P 520094
A (23439) A520308

ON-SITE SEWAGE DISPOSAL SYSTEM HOWARD COUNTY HEALTH DEPARTMENT BUREAU OF ENVIRONMENTAL HEALTH

PROPERTY KNOWN AS:
 LOT 7
 VALLEY ANNE ESTATES
 PLAT NO. 3882
 HOWARD COUNTY, MD

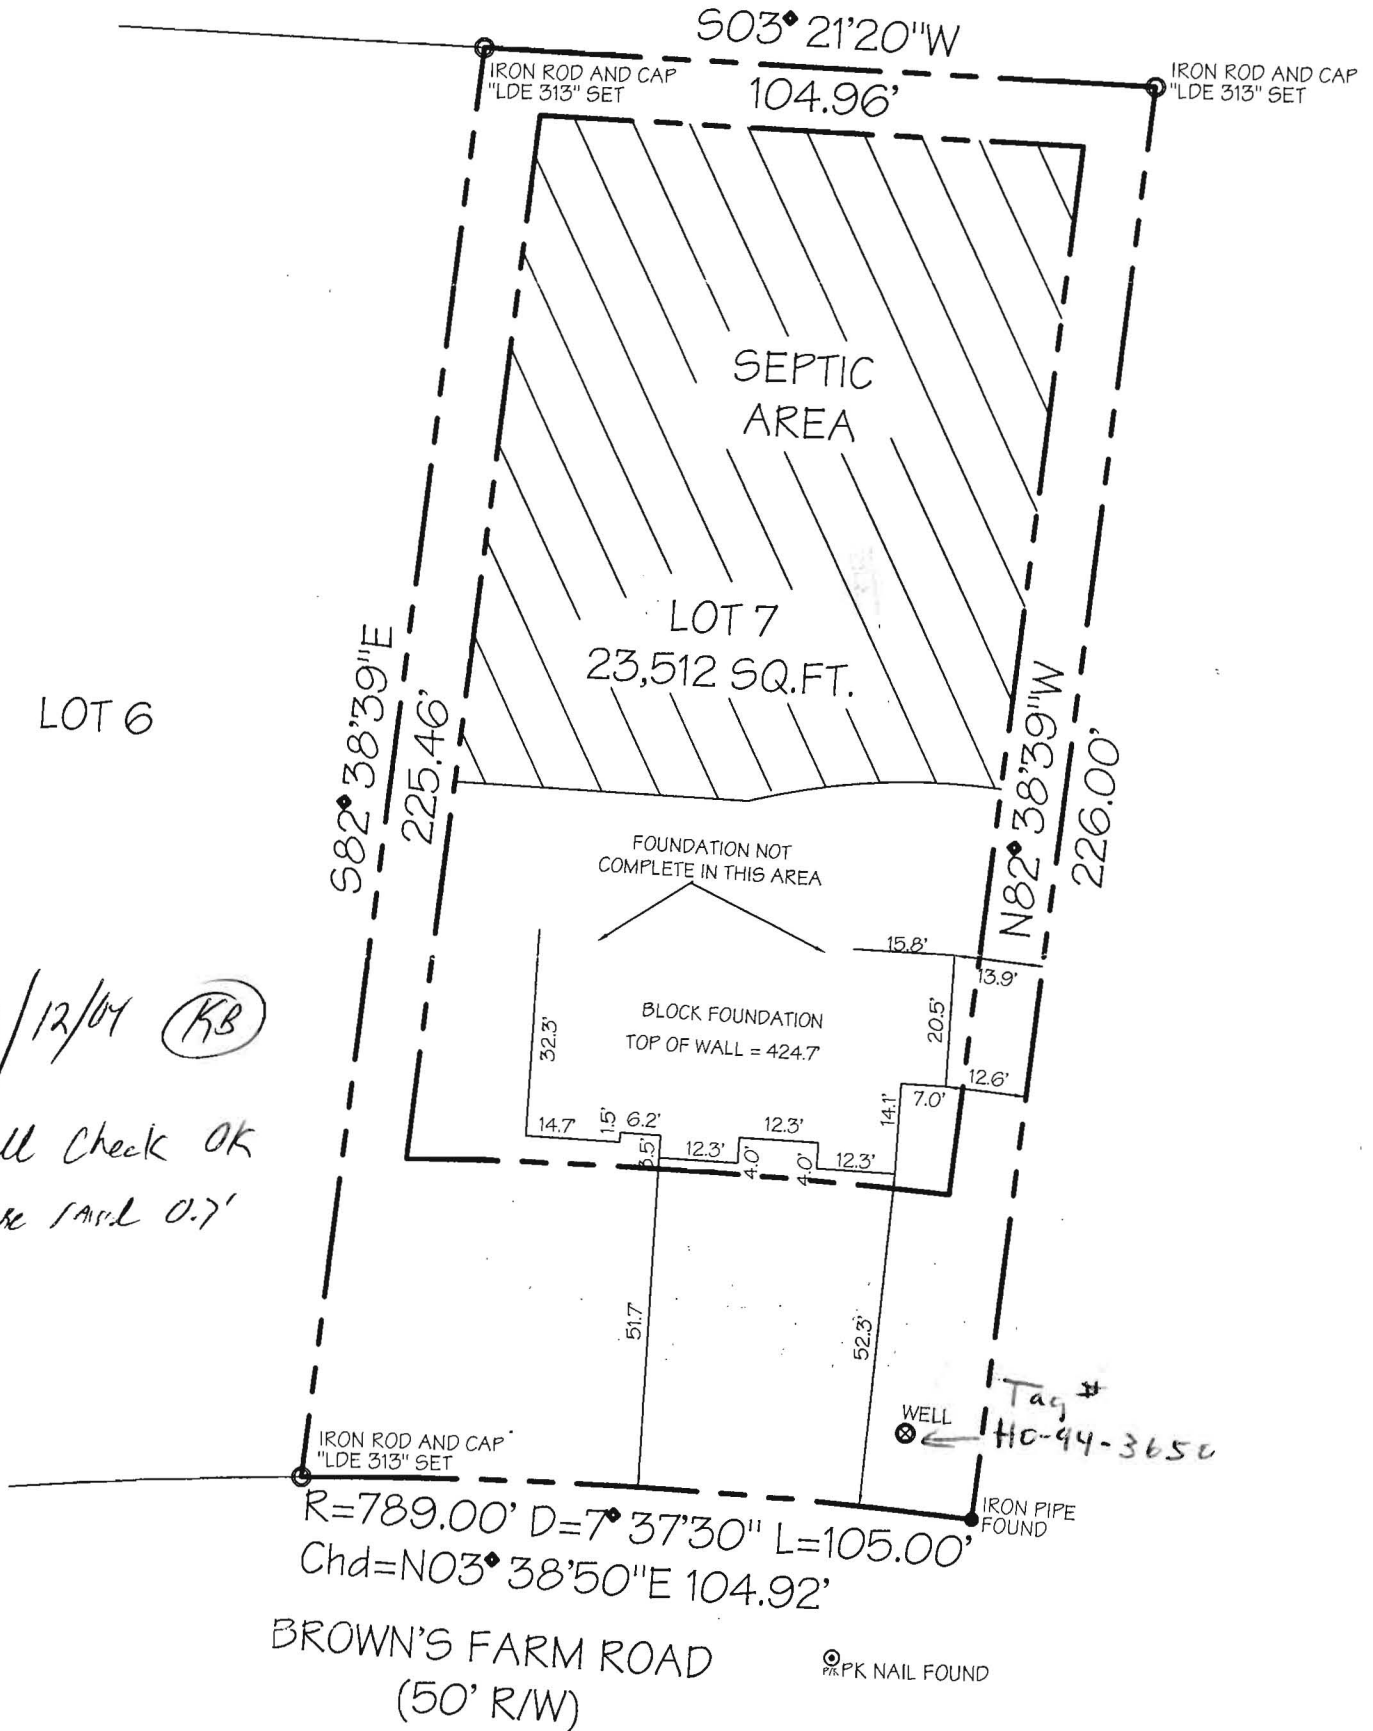
PRE-CONSTRUCTION 4/6/04 To install as per B.P. plan. Easement staked and contour loops accurate. (BB)

INSTALLATION 4/6/04 First trench done. Need house connection. (BB)

4/7/04 - OK to cover all work (SO)

Wall Check OK
 Have sand 0.7'

LOCATION DRAWING

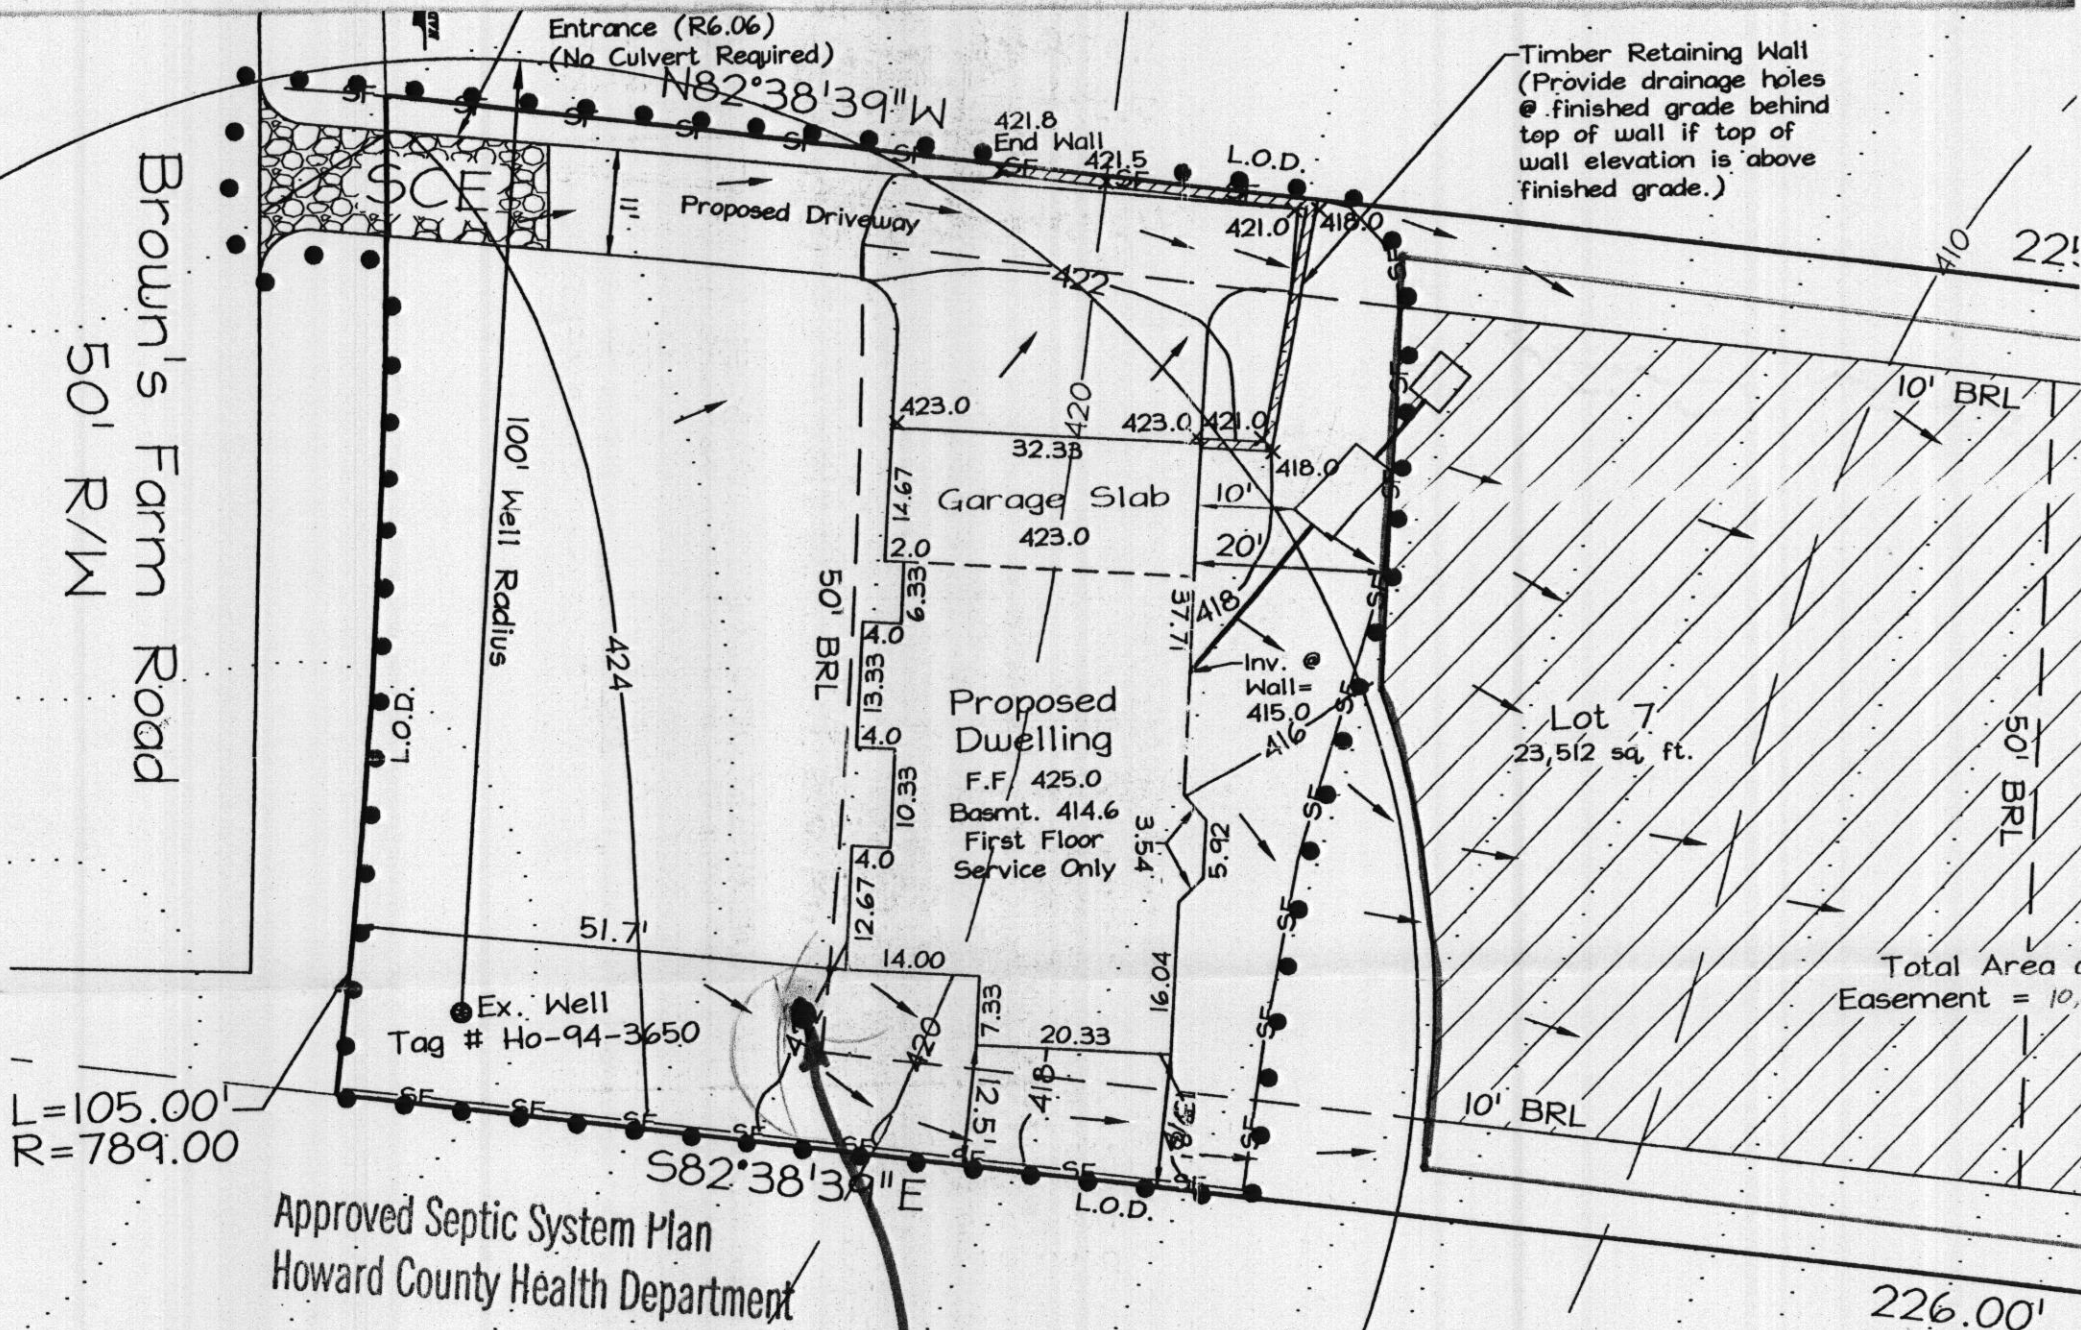
PROPOSED LOCATION
OF 1 LP TANK
34' FROM WELL
ACCEPTABLE
FOR BP 145416

Note: Revised Sewage
Easement total
square feet, shown
red, to meet s
requ requirement. T
done due to the s
8/29/03 JAB
